STRATEGIC DEVELOPMENT COMMITTEE

Report of the Corporate Director of Place Classification: Unrestricted

Pre-application presentation

Reference	PF/19/00234
Site	Ensign House,
Ward	Canary Wharf
Proposal	Redevelopment of the site to provide a residential building up to 53-storey.
Applicant	Far East Consortium
Architect	Maccreeanor Lavington
Agent	DP9
Case Officer	Nelupa Malik
Key dates	Pre-application request submitted October 2019 Pre-app discussions began in October 2019 CADAP review in October 2020

Proposed Scheme Presented before CADAP at 60-storeys.

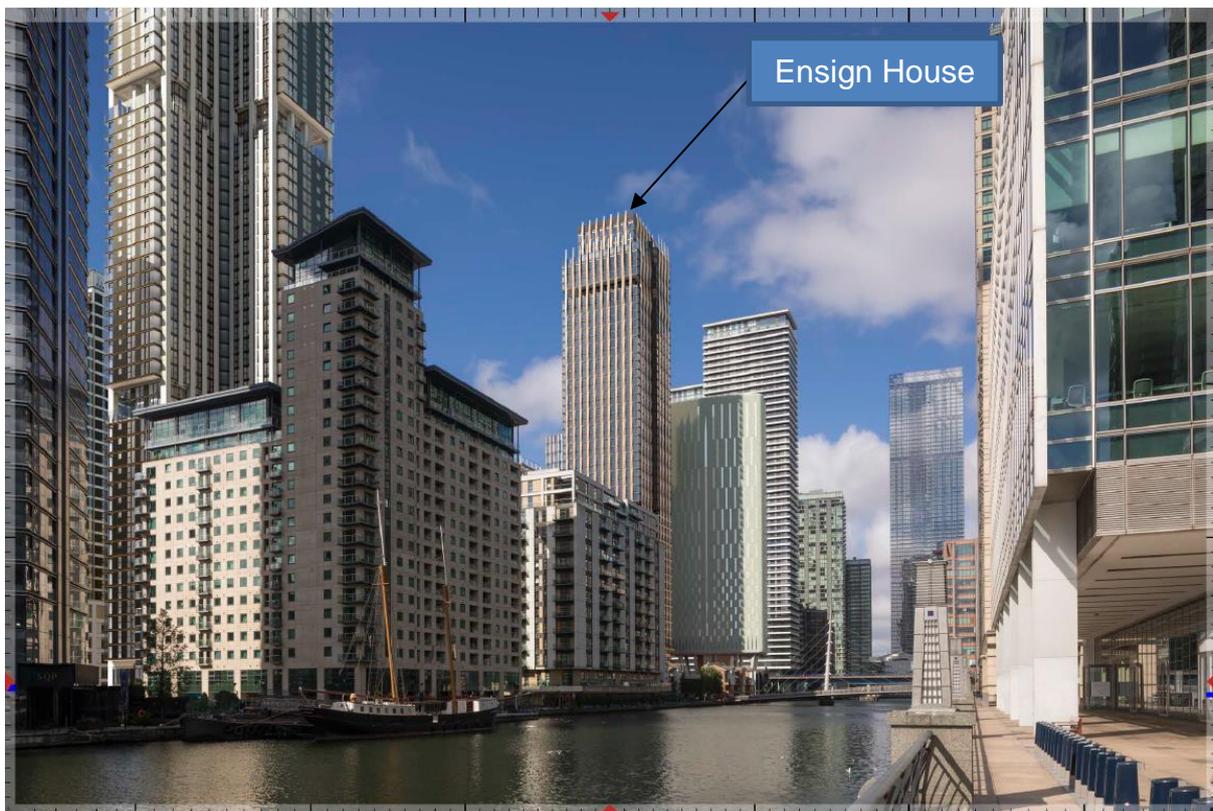
- Support the plinth, middle and top approach to design however highlighted that all the tall buildings shown in the developer's presentation were in fact commercial buildings and not residential. Residential buildings have different performance requirements.

- Panel members sought clarification on the sustainability aspirations for this building and suggested that overheating may be one of the biggest issues.

- Panel members admired the façade treatment however questioned its function and considered that it was important that the architectural expression did not appear simply 'stuck on'.

- Questions were raised as to whether there were any environmental benefits from the elevational treatment.
- Panel members were concerned that the scheme was referencing office buildings and that this resulted in a bulky footprint and a plan more suited to a commercial use than residential use.

- Concerns were raised about the quality of the flats with some floors having 12 units per floor and many of the flats were single aspect with no external amenity space.

- Concerns were raised that the scheme included 55% dual aspect units only.
- The absence of private amenity space for the private units were a concern and the approach to incorporate additional space internally and have large window openings instead was questioned.

- The proposal to have two lobbies; one for the private flats and one for the affordable was considered to create a 'poor door' effect.
- The panel members questioned the cycle parking provision which is proposed to be situated on two levels and the notion that these areas can be counted as amenity. Considered that this could work against the public face of the building.

- The panel supported the ambitions of the open space strategy, however noted that Marsh Wall has very poor air quality and raised concerns about the location of play space in relation to air quality.

- The panel expressed concerns about an imbalance between play and public space and the location of play space, much of which appears to be indoors.
- The panel noted that the play space for different age groups was entirely separated. Play space should be designed for the mix of different age groups.

- Concerns raised about how various development sites along Marsh Wall could be linked up.
- Support given to the covered walkway beneath the DLR and the opportunity of providing a colonnaded space was an exciting concept, however consideration needed to be given as to how this might work in practice.

- Overall, the panel felt the scheme offered an interesting architectural aesthetic, but before the height could be supported further work was required to resolve the issues arising from the plan as a result of the bulky footprint, amenity and open space issues. There is also a need for more work on sustainability.

Proposed Tower at 53-storeys.

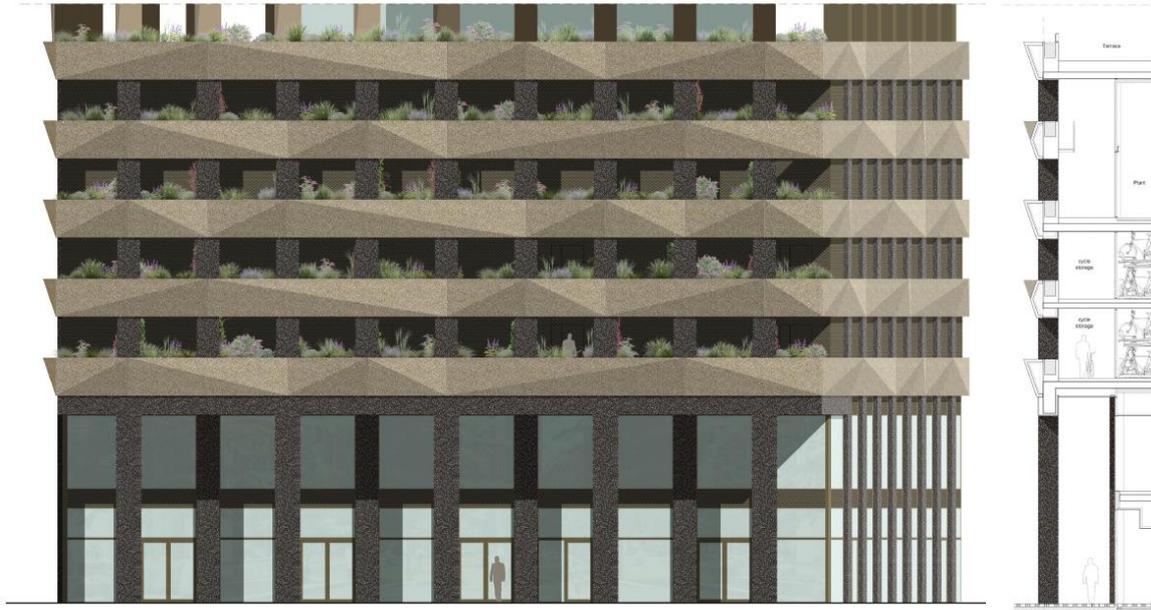
7.26 The scheme proposes a plinth and tower approach for the building. Concerns have been raised by Officers with regard to the height and massing of the proposal throughout the pre-application process. Officers have previously suggested that a scheme incorporating a height of 50-storeys would be more appropriate in this location and aligned with policy D.DH6 of the Local Plan, particularly in relation to the site's location on the edge of the Canary Wharf Tall Building Zone. However, Officers acknowledge that a 53-storey building that has a far greater level of articulation, detailing and design quality than that which is currently proposed could have the potential to appropriately respond to the tall building policy.

Proposed Plinth .

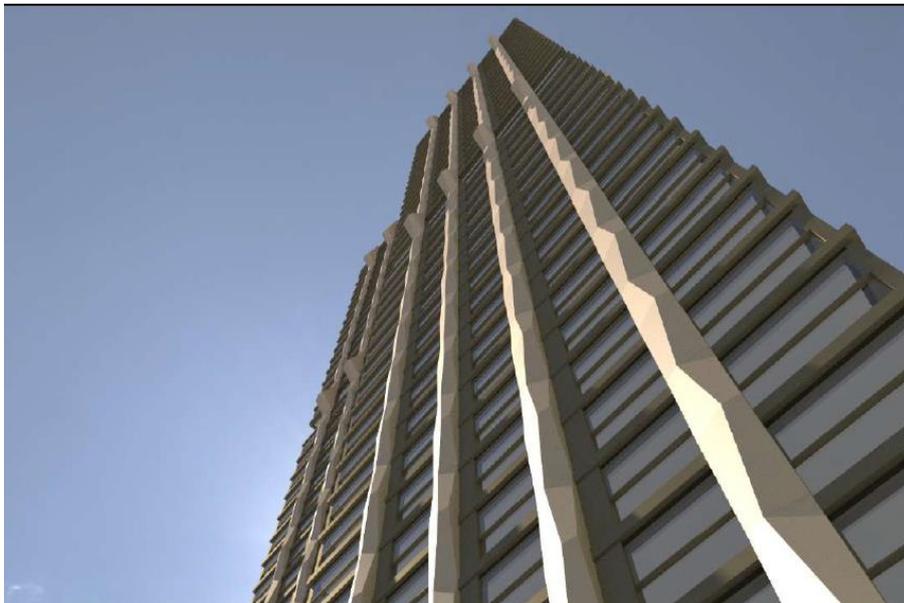
7.27 In terms of the proposed architectural treatment, the development proposes to express the building using copper/bronze coloured angular projecting fins arranged vertically. The materiality for the plinth is proposed to be polished concrete arranged horizontally and, in a colour/tone to reflect the material colour of the tower. In principle, Officers consider that this approach is interesting however further detailing is required with regards to its articulation to ensure that the quality of the development comes through successfully at an appropriate height.
